DOCUMENT 00914

ADDENDUM NUMBER 04

Project name: New Legislative Parking Garage
State Project Number: 81284-B
Project Address: 33 CAPITOL STREET
CONCORD, NH 03301

1 SECOND FLOOR DIAPHRAGM REINF. PLAN
SK-004 SCALE: 3/32" = 1'-0"

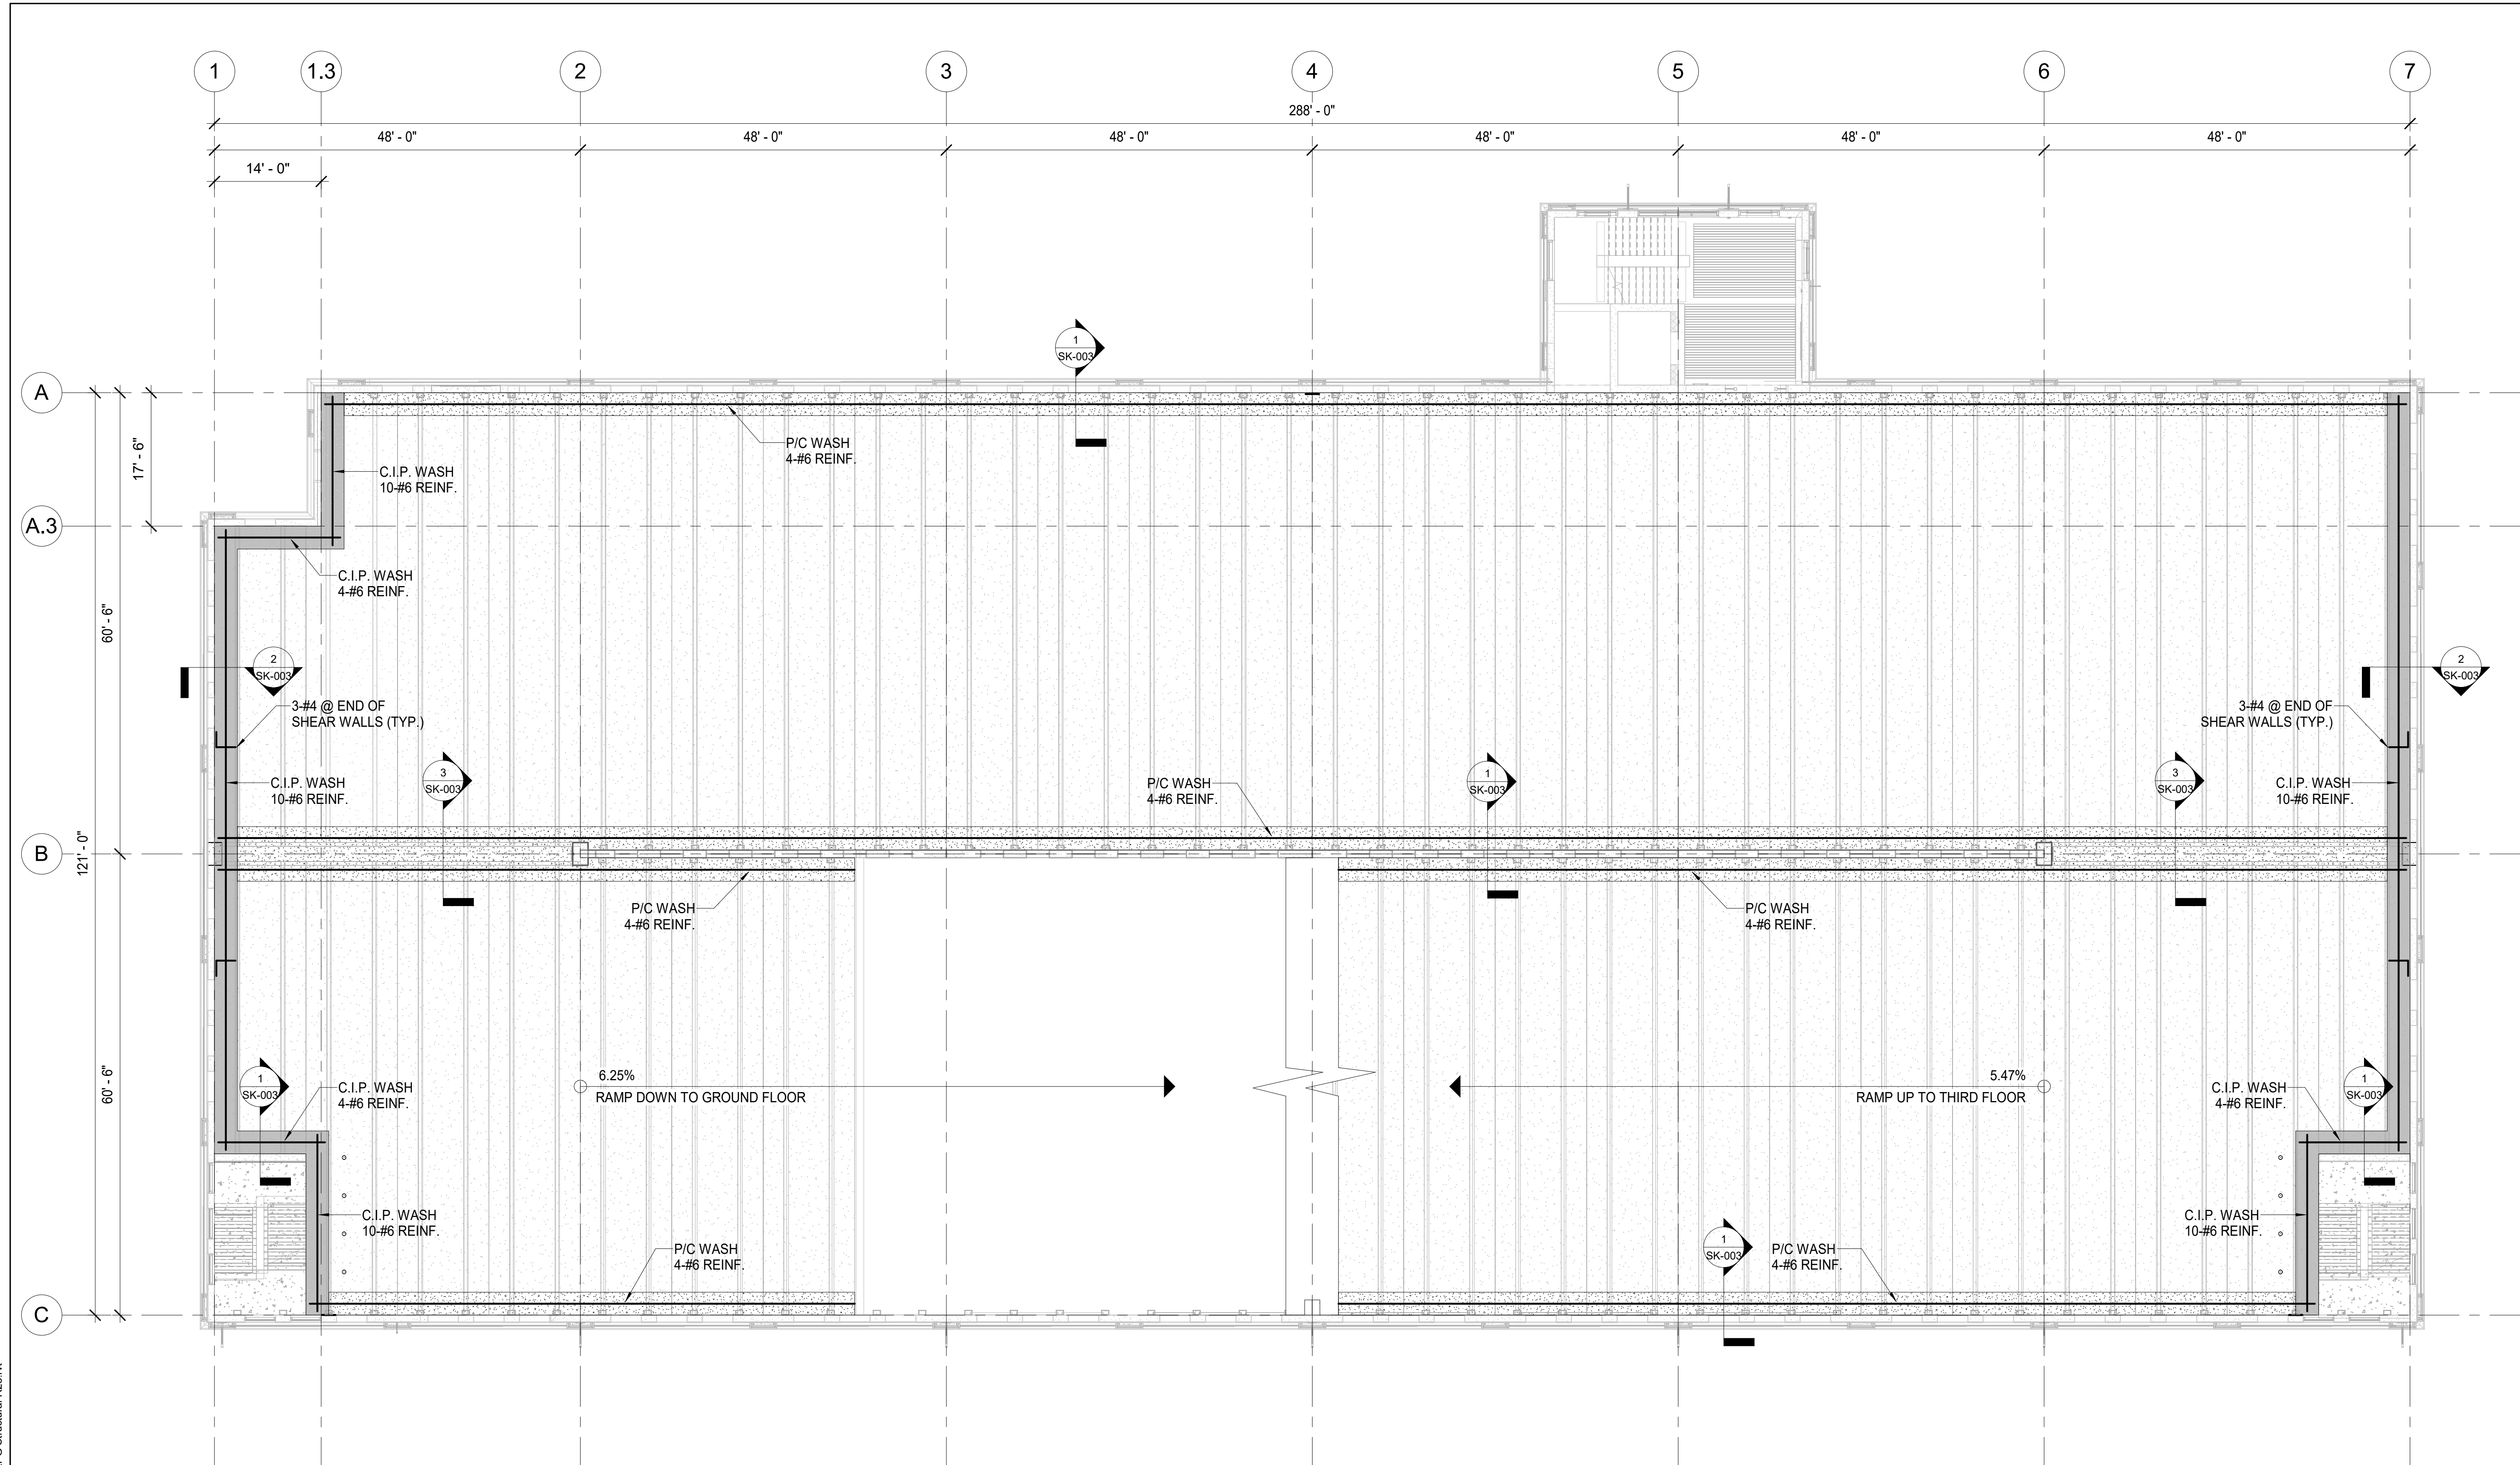
22. SK-003, SK-004, SK-005, SK-006 (as titled in the table at the beginning of this addendum).
 - A. Add SK-003, SK-004, SK-005, and SK-006 to the structural drawings.

1. In further response to Addendum 3 Question #6, these sketches are being added to the drawing set. They provide supplemental information about changing the precast washes to cast in place washes to better comply with Seismic Design Category C requirements. These sketches provide drawings and details showing the extent of cast in place washes and diaphragm steel.
